Asheville
Road Safety Audit 3 Report
US 25
(Merrimon Ave./Broadway/Biltmore Ave.)

November 4 - 5, 2015

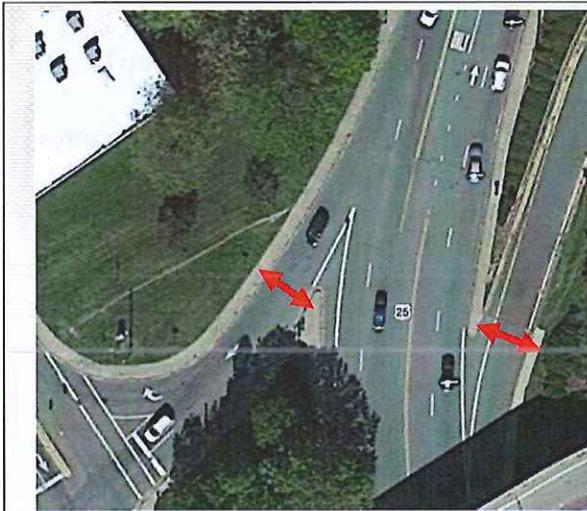
ramps are present but there are no signing or pavement markings to identify a pedestrian crossing

- Limited sight distance northbound on US 25 for drivers to see pedestrians crossing ramp because of bridge pillars

SB - The sidewalk ends, leaving pedestrians stranded

- Pedestrian facilities are also discontinuous on the west side of US 25; instead of walking southwest 115 ft to the signalized crosswalk at Broadway, pedestrians routinely cross the slip lane at the "V," where there are no crosswalk, curb ramps, or signing

NB - The sidewalk ends, leaving pedestrians to cross at their own risk. This particular pedestrian was pushing a stroller and lived close to the intersection. She complained about not feeling safe when crossing the street.

- Observed northbound vehicles on US 25 making illegal left turn onto Broadway through double yellow lines
- Manhole cover recessed, which could cause bicyclists to lose control

- Install a high-visibility marked crosswalk across the I-240 WB entrance loop between the existing curb ramps
- Install yield line pavement markings across the ramp in advance of the crosswalk

- Install Pedestrian Crossing (W11-2) warning signs and rectangular rapid-flashing beacons (RRFBs) at the crosswalk to increase driver awareness; fluorescent yellow-green sheeting for the signs is preferred

- Consider review of pavement markings to accentuate sightlines between drivers and the pedestrian crossing location. Shifting oncoming drivers even a few feet further from the curb should improve sightlines between northbound drivers and the pedestrian crossing and signing

- Ensure adequate lighting is provided at the crossing
- Consider the following combination of improvements at the sidewalk "V" on the west side of US 25:

- Install ADA-compliant curb ramps and a high-visibility marked crosswalk across the slip lane to the I-240 WB entrance ramp
 - Install yield line pavement markings across the slip lane in advance of the crosswalk

- Install Pedestrian Crossing (W11-2) warning signs on either side of the crosswalk to increase driver awareness
 - Ensure adequate lighting is provided at the crossing

- Improve channelization to prevent illegal northbound left-turns from US 25 onto the southbound slip lane

Vegetation obscuring light fixture at SE corner of US 25/ I-240 EB ramps

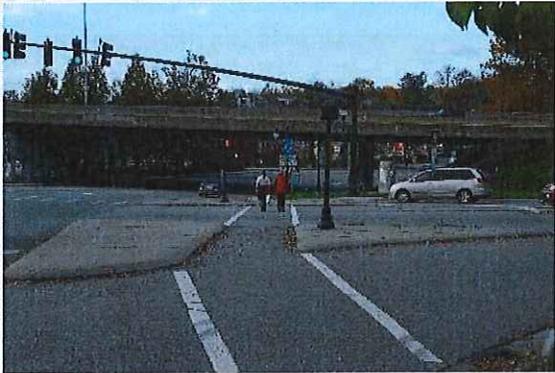
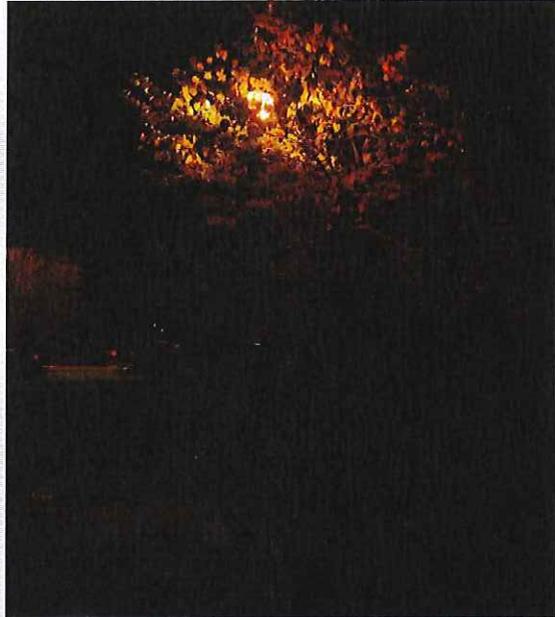
- Absence of yield line pavement markings at the westbound channelized right-turn lane
- Improper application of In-Street Pedestrian Crossing (R1-6) sign, which "shall not be post-mounted on the left-hand or right-hand side of the roadway"

- Five (5) collisions between southbound, left-turning vehicles and northbound bicyclists out of the 10 bicycle crashes in the RSA study area (2005-2014); this is possible because southbound left turns operate under permissive phasing

- Insufficient lighting of the pedestrian crossings
- Absence of 20 mph speed limit sign southbound before entering downtown
- Existing retaining wall and vegetation limit sight distance for NB drivers approaching the right turn onto I-240 EB ramp, which is a yield-controlled movement

- Install yield pavement markings at the westbound right-turn lane
- Remove In-Street Pedestrian Crossing sign
- Trim or relocate vegetation that is blocking current light fixtures
- Install "Reduce Speed Ahead" sign for vehicles driving southbound toward downtown; supplemental red/orange flags and/or pavement markings could also be considered
- Add 20 mph speed limit sign in location where the speed limit changes from 35 mph to 20 mph

- If it is structurally suitable, consider installing a "Turning Vehicles Yield to Pedestrians" (R10-15) sign on the existing mast arm for right turns from northbound US 25 onto the I-240 EB ramps to increase awareness of potential pedestrian crossings at that location

- Consider installing flashing yellow arrow signal, which could provide a red indication for the southbound left-turn lane when pedestrians utilize the push button
- Consider adding lighting where needed within the intersection

- Consider reconfiguring the westbound approach and restriping the northbound approach to include a second through lane. With these improvements in place, pedestrian crossing exposure is reduced on the east side of the intersection and level of service is improved from LOS D to LOS B in the PM peak with substantially reduced northbound queuing.
- To improve sightlines between NB right-turning drivers and pedestrians, consider one of the following:

- If trucks and larger vehicles can be accommodated, consider reconstructing the southeast corner with a smaller radius for the northbound right-turn onto the I-240 EB ramp, which would move the curb ramp further from the retaining wall, as well as slow right-turning vehicles
- Reconstruct the retaining wall further from US 25 to improve sightlines between NB motorists and pedestrians crossing the I-240 EB ramps; additional right-of-way would likely be required, so perhaps this could be considered in conjunction with any future redevelopment of this parcel

Westbound vehicle making a right-turn driving past the stop bar and crosswalk on a red light

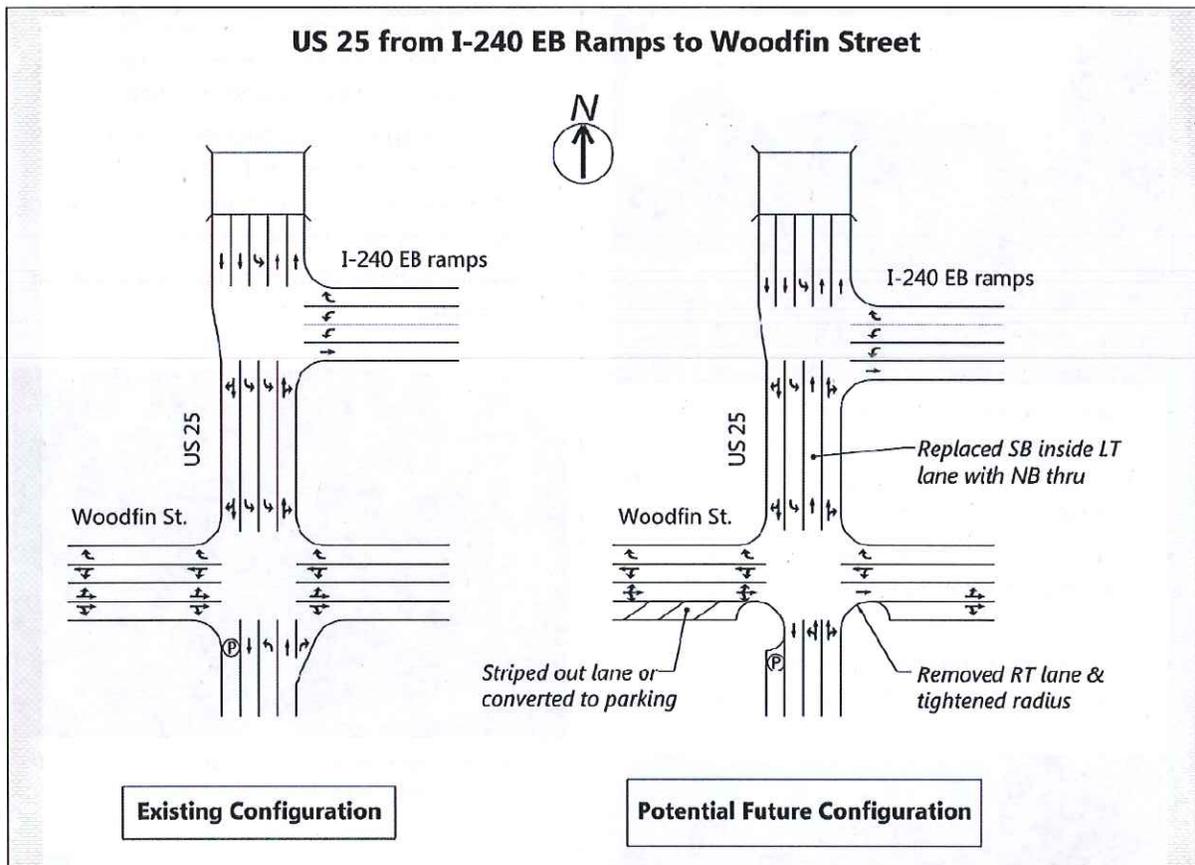
- Under current lane configuration, southbound through lane has to shift one lane to the left within the intersection because of on-street parking that begins at the far side without warning

- Pedestrians were observed crossing midblock and in front of the bus after off-loading on the north leg of intersection

- Because the east leg's stop bar and crosswalk are located far from the intersection, right-turning vehicles consistently drive past the stop bar and crosswalk in order to gain better sight distance
- Push buttons on the southeast corner are not in an accessible location for pedestrians with mobility restrictions
- Crosswalk on south leg is not straight, which pedestrians with limited vision could find difficult to cross

- Multiple drivers were observed to treat the northbound right-turn lane like a free-flow turn, as they failed to stop when their signal indication was red
- Intersection was not adequately lit during the night observation
- The crosswalk on the west leg is long and skewed

- Consider using striping (i.e., mini-skip pavement markings) to improve positive guidance for the southbound through movement
- Consider disseminating an audible message on local buses to encourage pedestrians to cross the road behind the bus and at a crosswalk after alighting the bus
- Relocate push button post and pedestal on the southeast corner to make them accessible to persons with mobility restrictions

- Based on the RSA observations and subsequent capacity analyses, the team recommends that NCDOT consider reconfiguring some of the through and right-turn lanes to shorten pedestrian crossing distances.
- Consider converting the northbound left-turn lane and southbound inside left-turn to a second northbound through lane via restriping. With these improvements in place, pedestrian crossing exposure is reduced on

- At the WB approach: consider installing "Stop Here on Red," "No Right Turn on Red," 5-section signal head with right-turn overlap, or "No Turn on Red" blank-out sign
- Improve lighting at intersection, especially at crosswalks

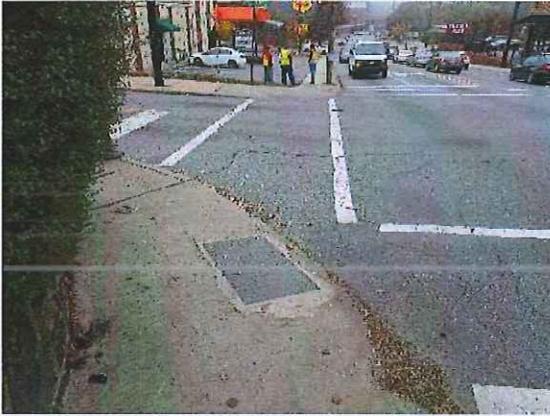
13. Intersection of US 25/Chestnut Street	
Issue Description	Suggested Action
<ul style="list-style-type: none"> Westbound and eastbound Chestnut Street had significant queuing due to vehicles yielding to make left turns; only two westbound vehicles were able to make it through the intersection in one particular phase that was observed 	<p>Near Term</p> <ul style="list-style-type: none"> Relocate sharrows to the center of the travel lanes in each direction on Chestnut Street
 <p><i>The westbound left-turning vehicles running the red light</i></p> <ul style="list-style-type: none"> Push buttons on northwest corner are difficult to access because of the position of the signal controller cabinet and pole, especially if pedestrian has mobility restrictions Crest vertical curve limits sight distance for northbound left in permissive phase Right-turn only sign is posted at Broad Street; are drivers compliant? Sharrows on west leg of Chestnut Street are inappropriately placed in the middle of the road Bus stop (northwest corner) has an additional seating area that is disconnected from the sidewalk and is only accessible by stairs Multiple driveways between Orange and Chestnut and no turn lanes lead to queuing in through lanes 	 <ul style="list-style-type: none"> Connect seating area at the bus stop on northwest corner to sidewalk  <ul style="list-style-type: none"> Trim or remove vegetation on northeast corner Add walk time to minor street to coincide with parallel green

- Vegetation encroaches upon sidewalk in northeast corner

- Short pedestrian walk time on minor streets, result in pedestrians crossing on "don't walk" phase because parallel vehicle phase is still green
- The "Be Prepared to Stop" sign on southbound Merrimon Avenue before the intersection of Chestnut Street begins to flash 4 seconds before yellow. This could be an issue if spillback occurs from the intersection because the crest vertical curve limits drivers' line of sight

- Move push button on northwest corner to a more accessible location in relation to the curb ramp
